New Albany Architectural Review Board Agenda
Monday, November 8, 2021 7:00pm

LOCATION: 5526 Dublin Granville Road and 5321 Harlem Road (PIDs: 222-003431 and 222-002058)
APPLICANT: M+A Architects c/o Jeff Hefner
REQUEST: Certificate of Appropriateness & Waivers
ZONING: Agricultural (AG)
STRATEGIC PLAN: Residential
APPLICATION: ARB-99-2021

LOCATION: 5526 Dublin Granville Road and 5321 Harlem Road (PIDs: 222-003431 and 222-002058)
APPLICANT: M+A Architects c/o Jeff Heffner
REQUEST: Certificate of Appropriateness & Waivers
ZONING: Agricultural (AG)
STRATEGIC PLAN: Residential
APPLICATION: ARB-99-2021

NEW ALBANY PRESBYTERIAN CHURCH

SITE PLAN

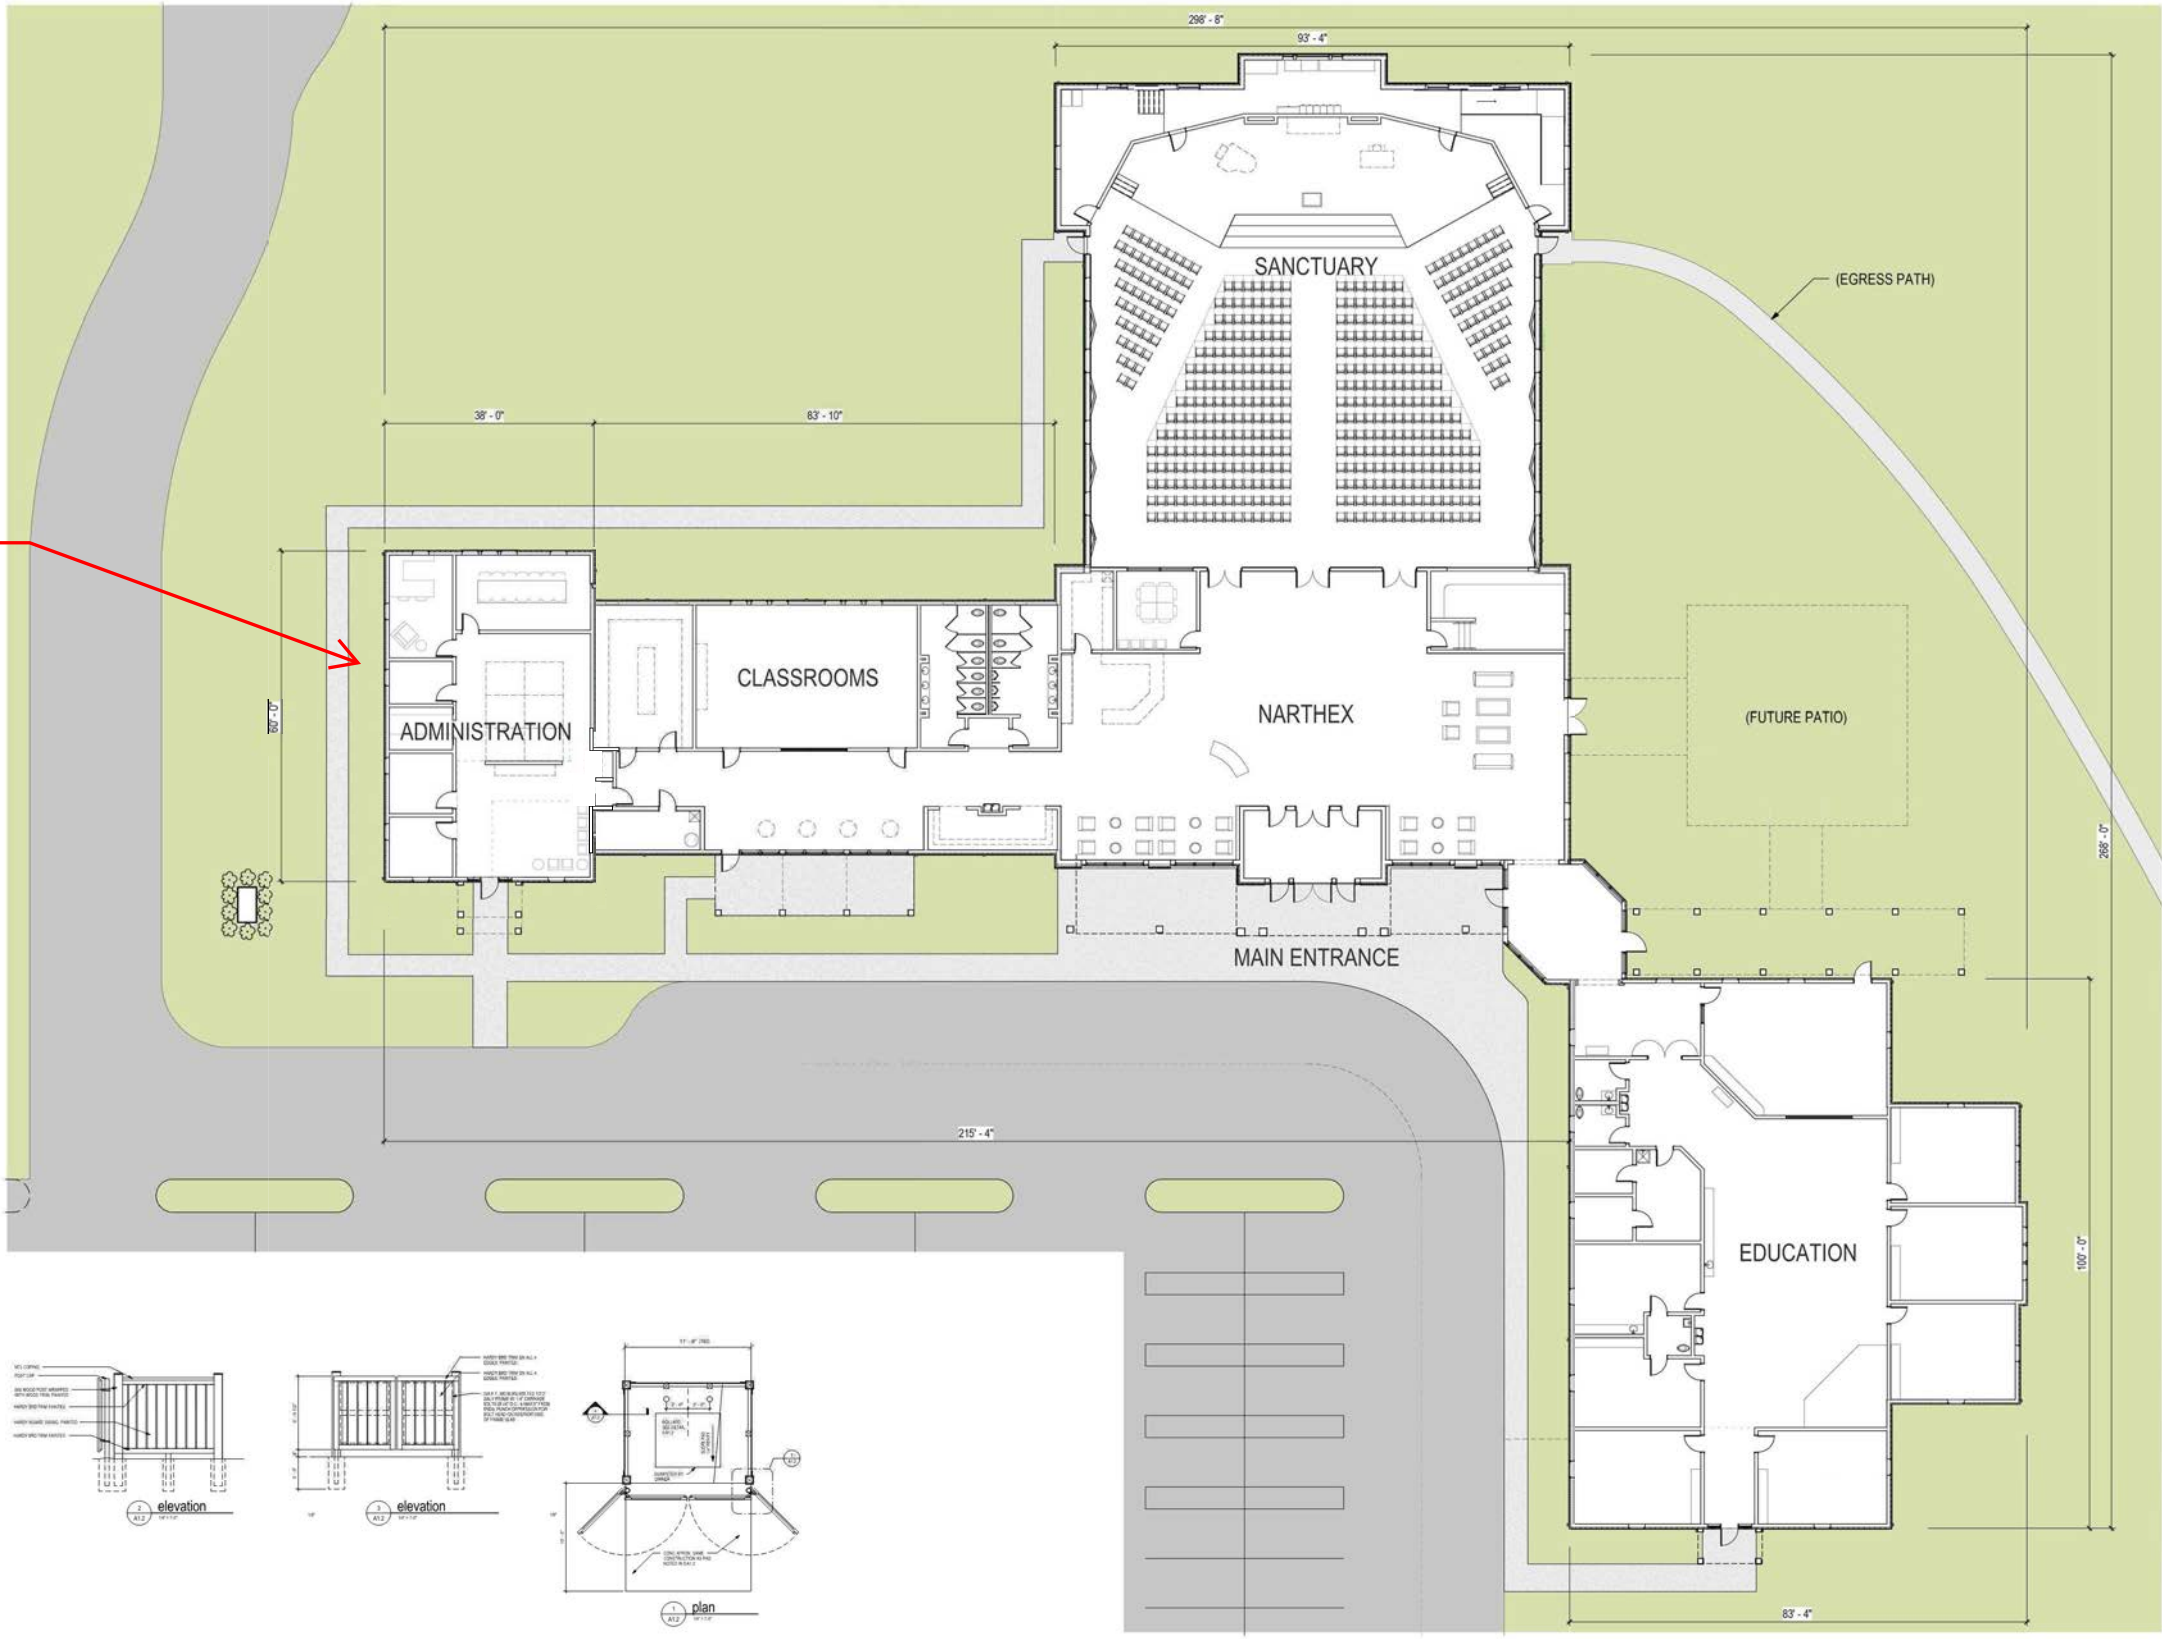
SHIFTED ADMINISTRATIVE WING NORTH TO CENTER ON NARTHEX MASS

SOUTH ELEVATION

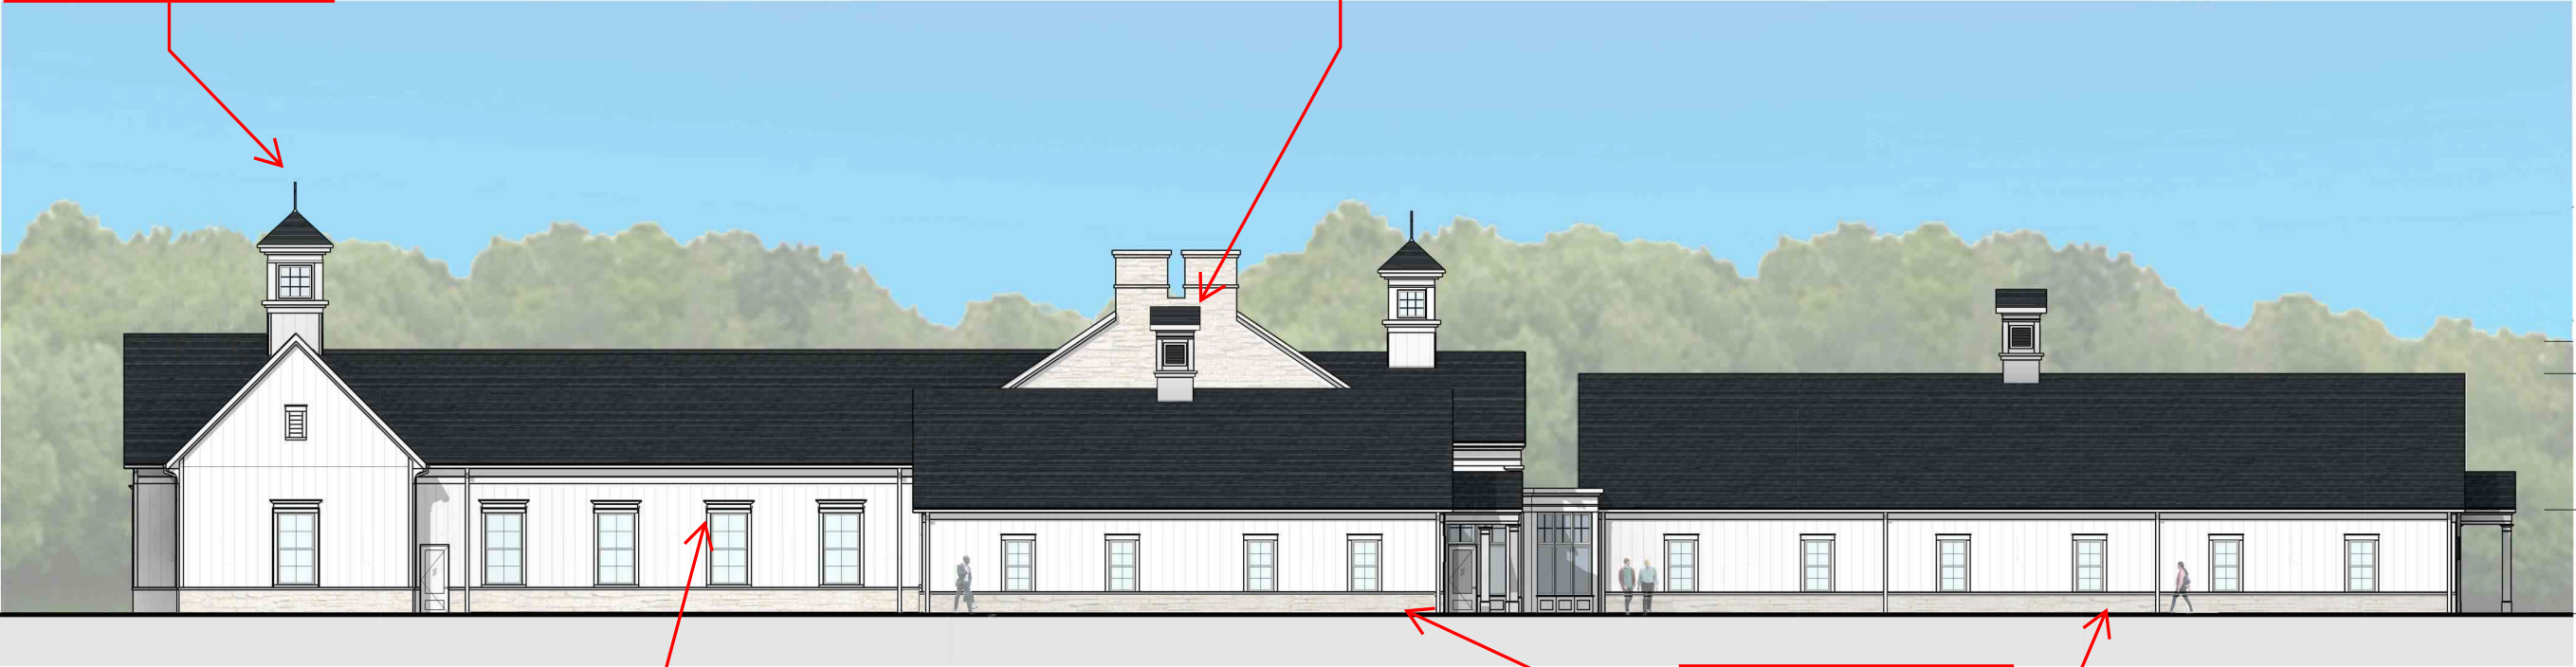
- Increased the column width along the southern elevation of the building.
- Enlarged pilasters were added behind each column on the southern elevation of the building.

- A stone plinth/water table was added to the entire building replacing hardi plank which was previously proposed on certain building sections.
- The cupola on the northern elevation was shifted and centered with the west/east gable.
- The board-and-batten pattern was eliminated in the pediment and revised to be a smooth panel.
- Panels were added below the large windows on the northern elevation, breaking the stone water table, to enhance the look of a front door.
- The administration wing shifted north to be on center with the narthex massing and to align with the smaller cupola in the narthex centerline.
- The same window trim detail used on the northern elevation is now also used on the side of the sanctuary to achieve 4-sided architecture.

STONE PLINTH AND WATER TABLE HAS BEEN ADDED TO THE ENTIRE CHURCH.

THICKER COLUMNS WITH ADDED ENGAGED PILASTERS

Landscape Plan
SCALE: 1" = 40'-0"

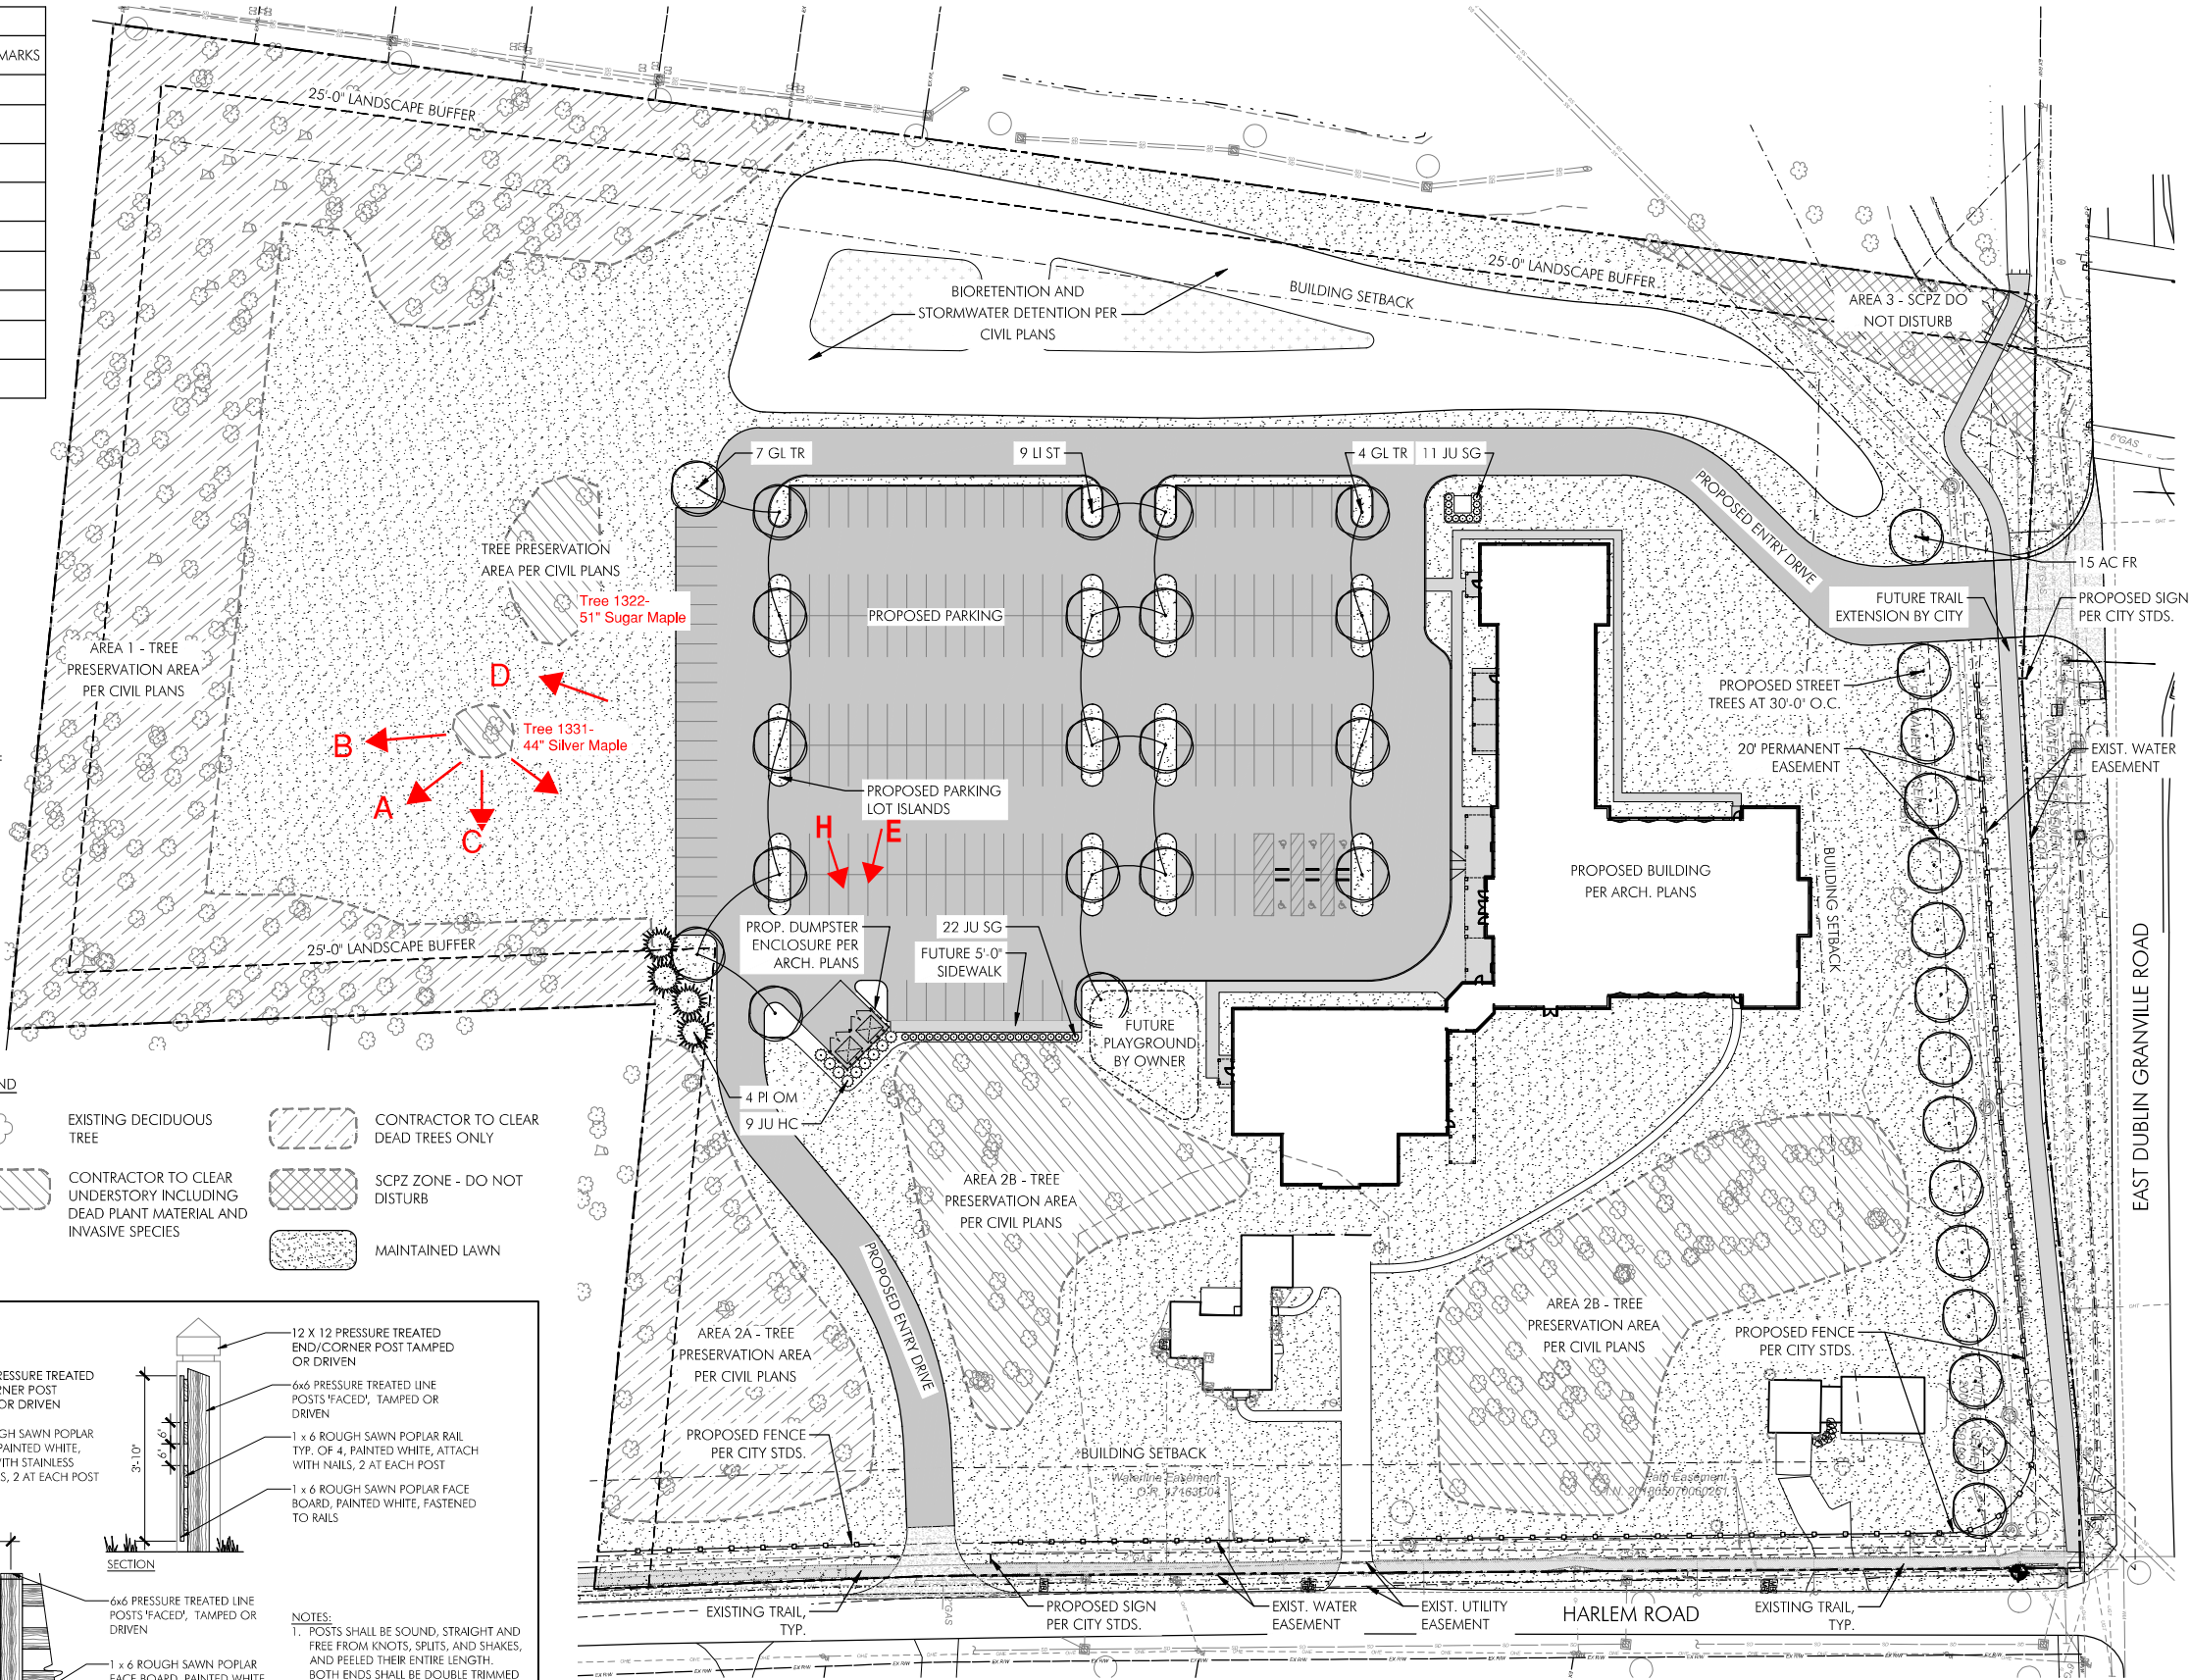
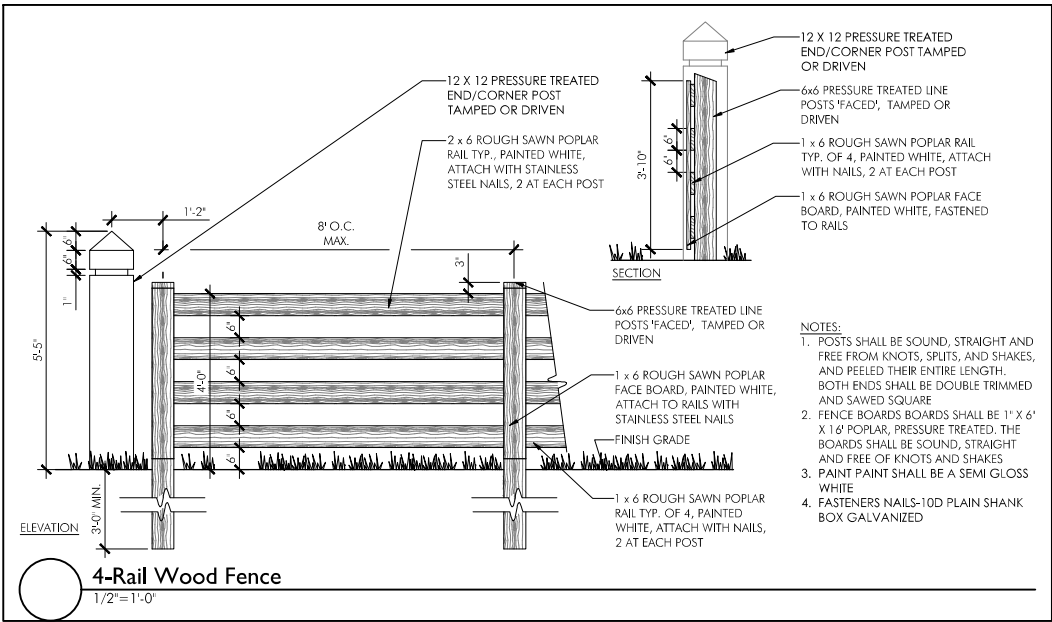
1. Street trees along Dublin Granville Rd should be planted in random massings of native deciduous shade trees. Include more variety of species and provide the required quantity of trees.

2. Street trees along Harlem Rd should be planted in random massings of native deciduous shade trees.

3. Provide planting in basin in order to meet 75% screening opacity in 5 years from installation. Trees should be planted with naturalized spacing and grouping.
4. Consider naturalizing the evergreen screen with more species of trees and a randomized spacing.

- All waivers related to the landscape requirements for the site have been withdrawn.
- Additional landscape screening/plantings have been added in select locations along Harlem Road in order to provide additional screening.
- Additional plantings have been added along the western and southeastern property line to achieve 75% opacity screening.
- Street trees have been added along Harlem Road and Dublin Granville Road that meets code requirements.
- A parking lot hedgerow that meets code requirements has been added around the entire parking lot area.
